From: Amy Ball <aball@horsleywitten.com>
Sent: Friday, October 09, 2015 10:01 AM
To: Monica Mejia
Cc: Jeffrey Ribeiro; Jonathon Idman; Richardson, Bill; Magner, Maryann; Baptiste, Irvin
Subject: Provincetown Airport - clarification on topography and groundwater elevations
Attachments: 09 - 4027_GD-REV1.pdf; 10-11 - HW-4027_DE-REV1.pdf

Provincetown Airport

**PROPOSED PHASE 1
 PARKING LOT GRADING AND DRAINAGE**

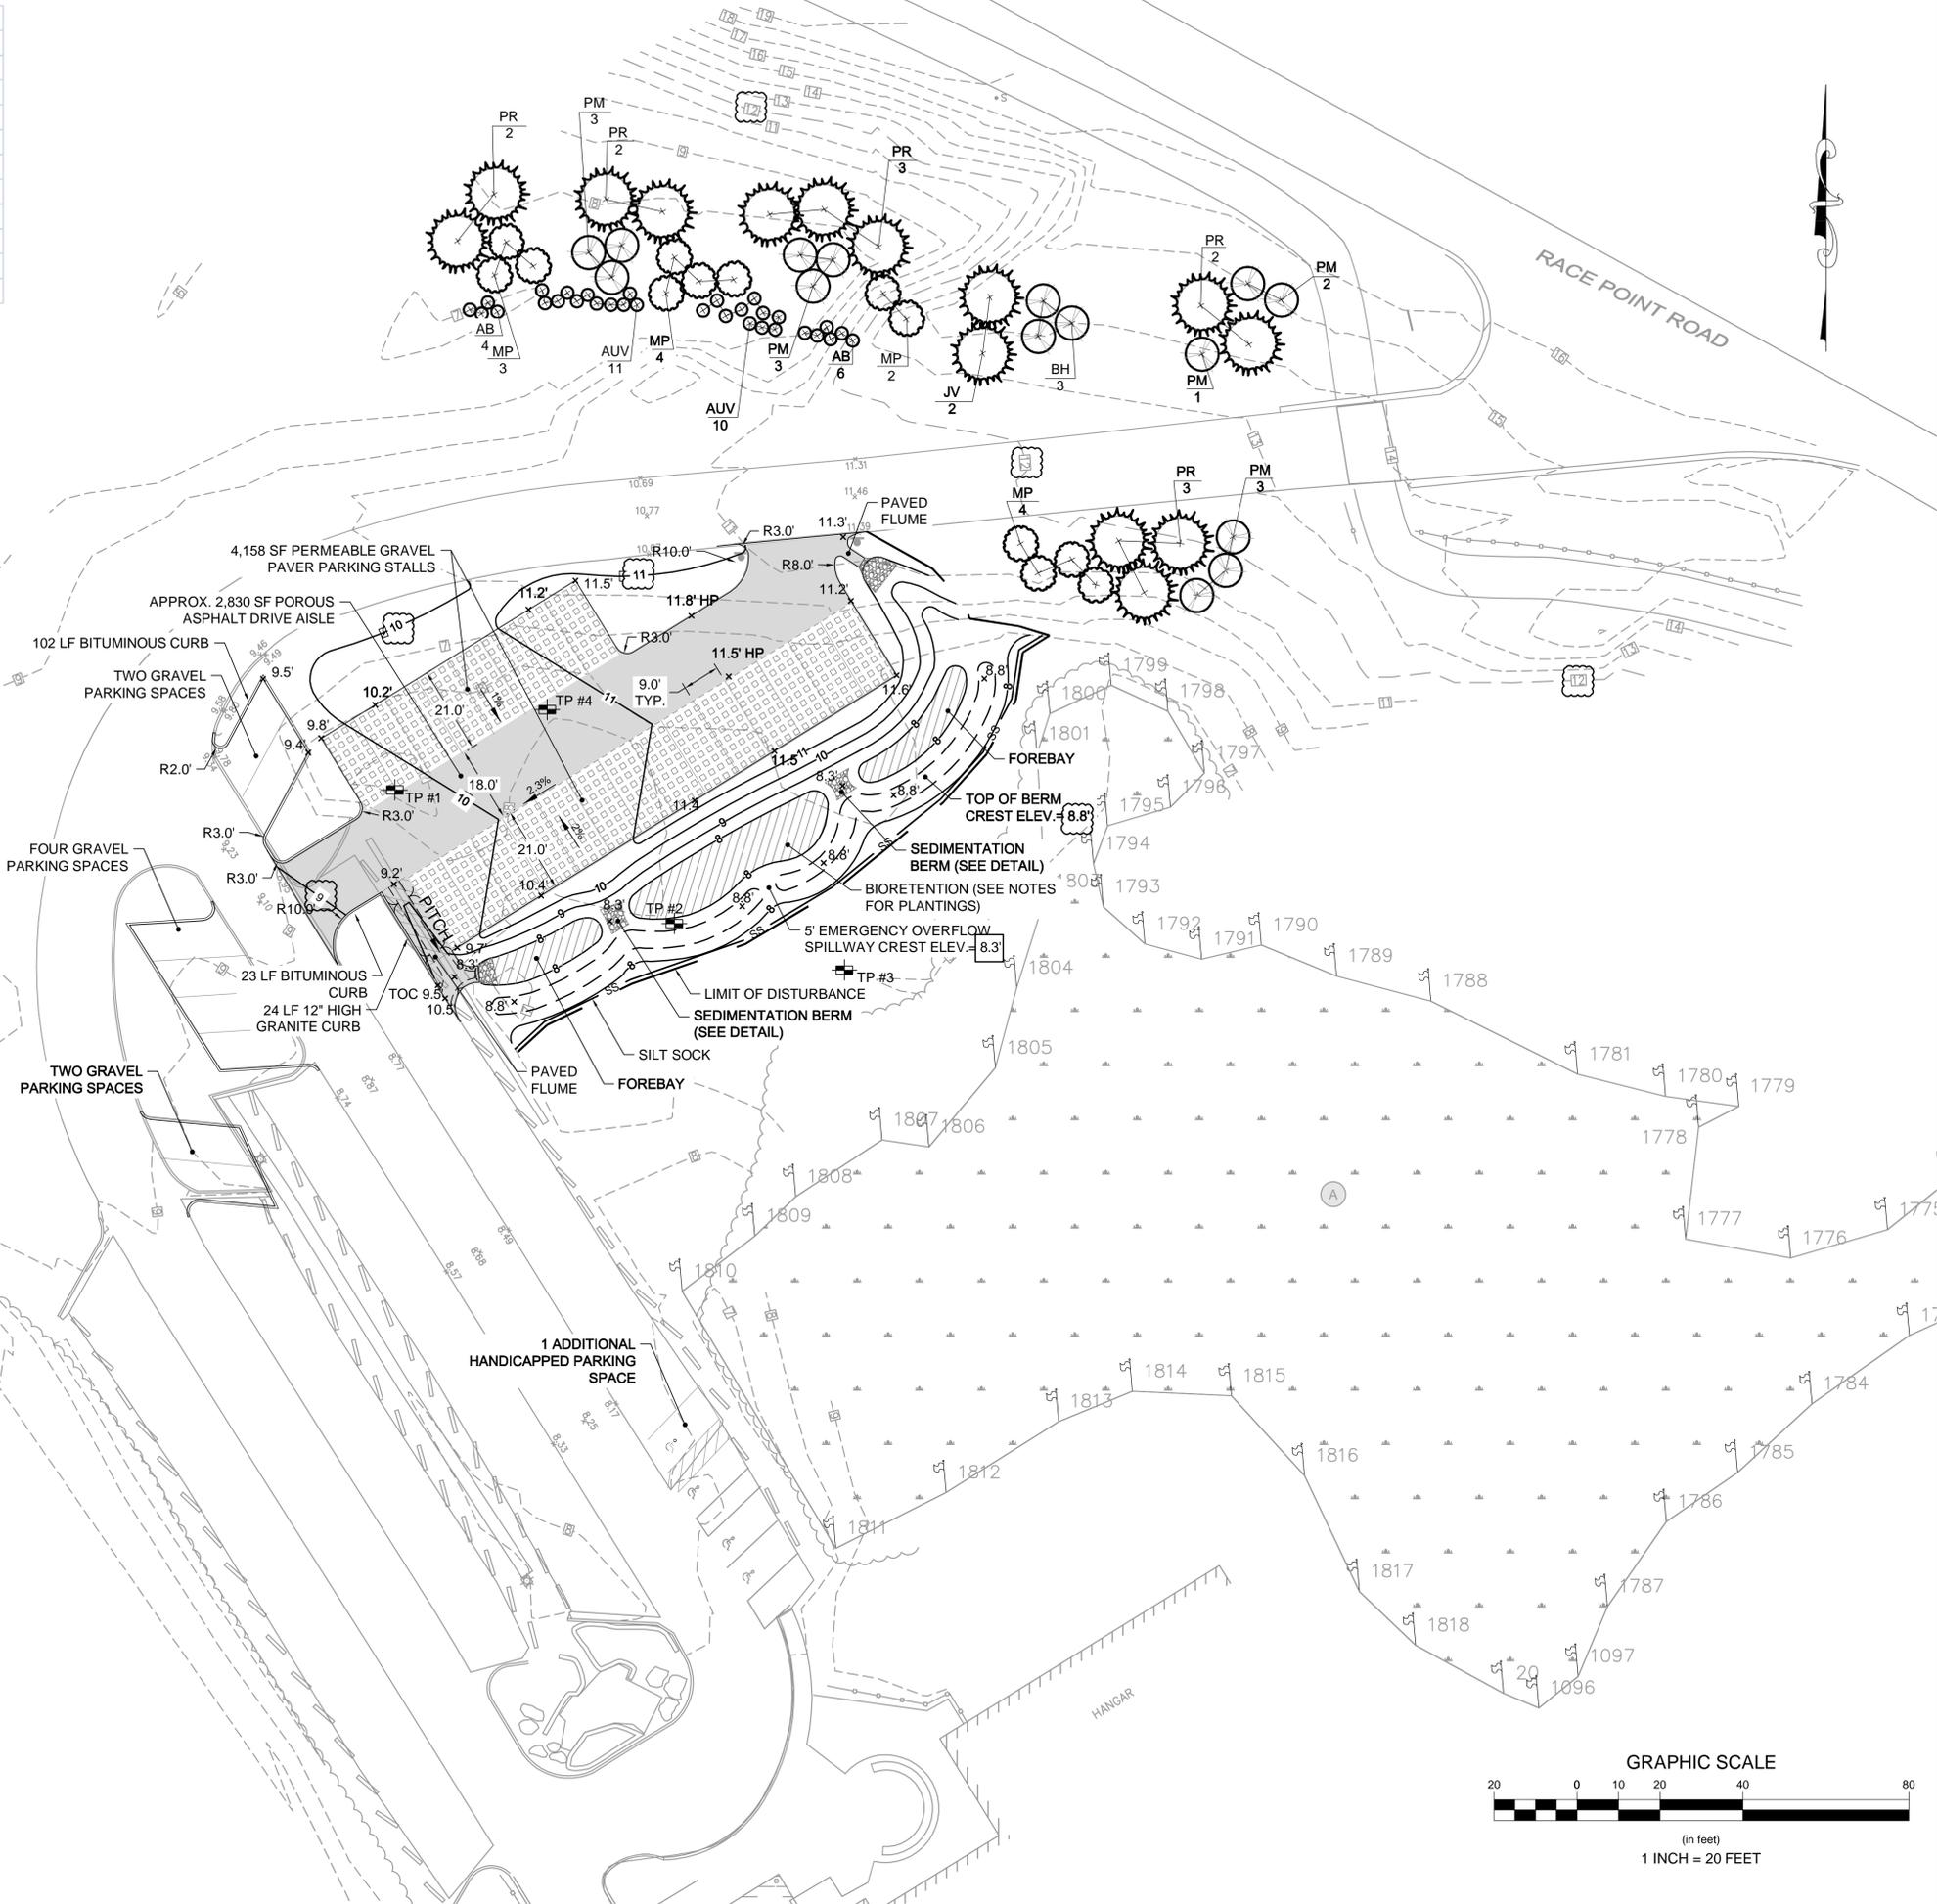
The long explanation is that the topography surveyed at the Airport is in a specific datum relative to an Airport benchmark. The topography and the grading for the parking lot had originally been corrected to conform to NAVD (as noted in the table). However, the remaining portions of the Airport topography were in the Airport datum. It would have been an enormous undertaking to adjust all of the data by hand, and since it didn't make sense to use two different datums on the plans, we reverted back to the "Airport datum" for the parking lot area. Unfortunately, a couple of the adjusted labels surrounding the parking lot area were overlooked. The two attached sheets (Sheets 9 and 10) provide the corrected data. The changes are off-set with a square or "cloud." With these corrected contours, and using

only the Airport datum (not NAVD), there is a 2 to 3 foot separation for infiltration for the parking lot, but the separation is not 3 feet across the entire area, thus, the request for flexibility from those applicable MPSs in our DRI application.

REV. NO.	DATE	DESCRIPTION
1	10/08/15	REVISED ELEVATIONS
